Technical Bulletin

Bulletin No.: PRO-03-06 Effective Date: 8/9/76 Page: 1 of 2

Subject: **QR-1 Valve**

INSERT FOR QUICK RELEASE VALVE

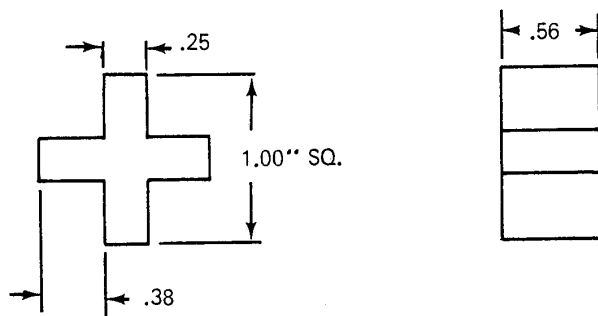
Over the years, we have received complaints of noise in the QR-1 valve when it is exhausting. Engineering has come up with a good fix, which field testing has proven eliminates the noise. The fix is a small piece of polyurethane foam material cut in the shape of a cross and placed on top of the diaphragm. The insert is #292362. The part number of a QR-1 valve with the insert is piece #289042. Piece #289042 has 3/8" supply port and 1/4" delivery ports. This valve #289042 has 1 psi supply and delivery differential.

The insert can be used in any QR-1 valve to eliminate the noise. The insert #292362 is placed in the center of the diaphragm on the top side or supply side of the diaphragm.
